AERONAUTICAL CHARTING FORUM
Instrument Procedures Group
April 29-30, 2002
HISTORY RECORD

FAA Control # 02-01-241

Subject: Non-radar Level and Climbing Holding Patterns

KAILUA-KONA, HAWAII
ILS DME Rwy 17

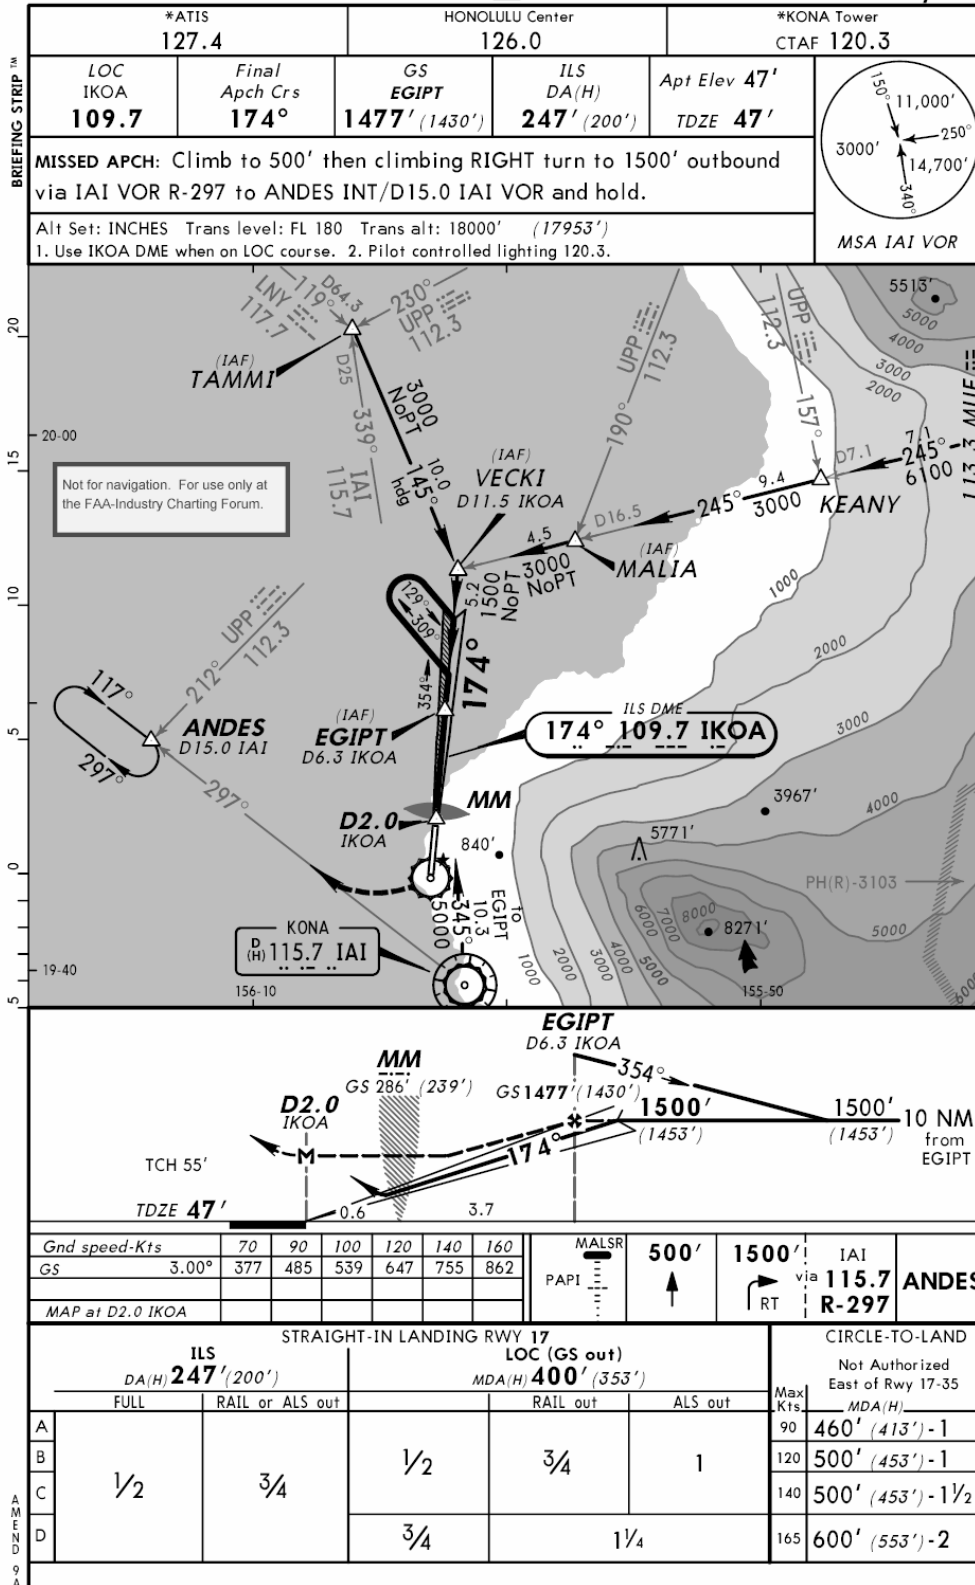
Background/Discussion: FAA holding pattern criteria and policies provide for 310-knot climb-in-hold (CIH) holding patterns for missed approach procedures used by jet airplanes where a 40:1 surface is penetrated in accordance with the criteria contained in 8260.3B, Paragraph 293b. Pilots have no way of knowing, however, which CIH patterns have been evaluated for CIH. Also, there are situations where a jet airplane CIH pattern does not trigger the provisions of 8260.3B, Paragraph 293b, so the pattern size used often provides for a maximum of 200 knots even though a modified CIH may be required. An example is attached, for the ILS 17 at Kona, Hawaii, (illustration attached) where the missed approach holding pattern is 40:1-free, and the holding altitude is 1,500 feet. But, a CIH to at least 5,000 is required to return to the approach procedure. Pilots have no way of determining what the maximum design speed is for CIH in any holding pattern. 200 knots is an inadequate speed for a transport jet airplane to climb in the Kona pattern, although 310 knots would be excessive.

Recommendation: CIH patterns such as in the Kona ILS 17 example, and all patterns used by jet airplanes where CIH is required, should be evaluated for 265 knots where 310-knot CIH patterns are not required. This requirement should extend to holding patterns for both missed approaches and DPs. Further, it should be made clear that the 310-knot CIH criteria apply to DP holding patterns where a Paragraph 293b evaluation finds 40:1 penetrations. Pilots should be informed, both by AIM reference material, and chart code, which patterns are authorized for 265-knot CIH and which are authorized for 310-knot CIH.
